REMARKS

The Examiner's Office Action of May 18, 2005 has been received and its contents reviewed. Applicants would like to thank the Examiner for thorough review and consideration given to the above-identified application, and for indicating that claims 7 and 9 contain allowable subject matter and would be allowable if amended to overcome a 35 USC §112, 2<sup>nd</sup> paragraph rejection.

FIG. 2

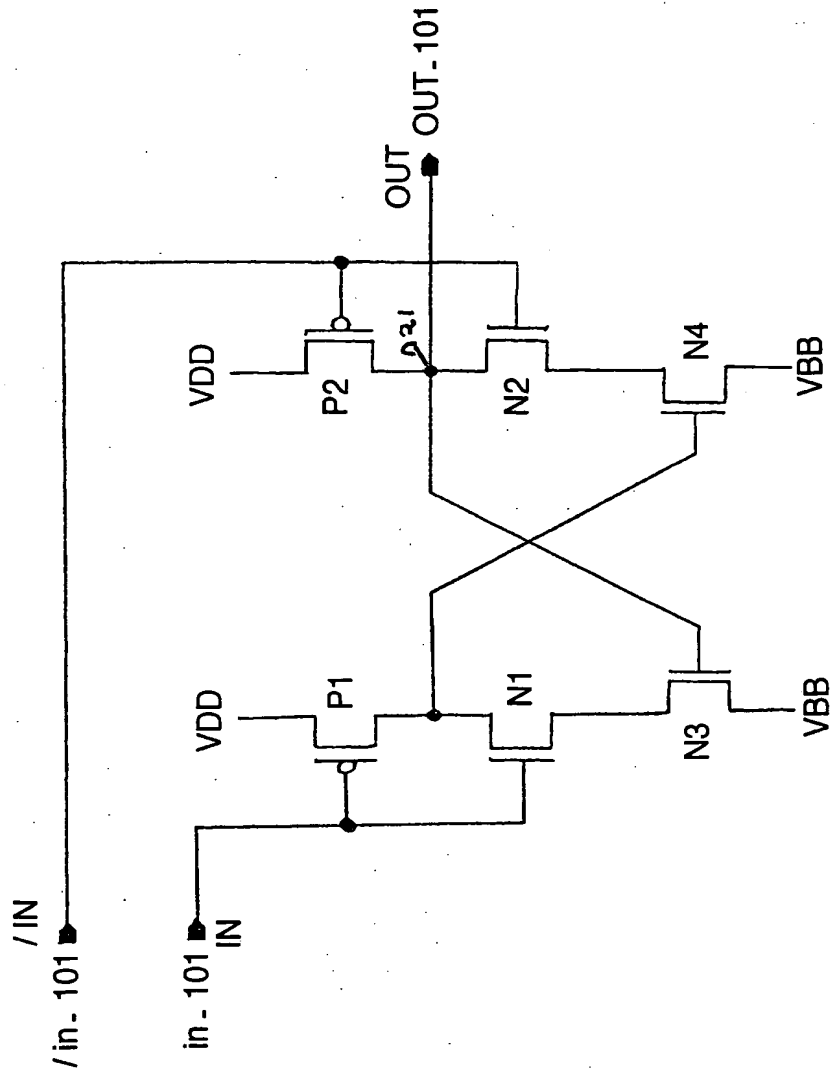
Referring now to the Office Action, the drawings stand objected to because Fig. 2 does not include reference to node "n21" and Fig. 3 does not include reference to nodes "n31" and "n32", as discussed in the specification. In response, Applicants submit herewith Replacement Sheets for Figs. 2 and 3.

The Examiner asserted that claim 2, lines 6-7, are misleading with respect to the gate of the second transistor receiving the input signal because transistors P1/P2 receive complementary input signals as shown in Fig. 2. In response, Applicants respectfully direct the Examiner’s attention to claim 1, particularly the following limitation:

Applicants note that the output substrate voltage VBB generated is also used as an input to the source of the 5<sup>th</sup> and 6<sup>th</sup> transistors N3 and N4, respectively, in Fig. 2. Also, VBB is used as an input voltage at the source of the 5<sup>th</sup> and 6<sup>th</sup> transistors N33 and N34, respectively, as shown in Fig. 3. This feedback of the generated VBB substrate voltage, although not explicitly described in the specification, is clearly shown in Fig. 1 with a connection of OUT.vbb to level shift circuits 101 and 102.
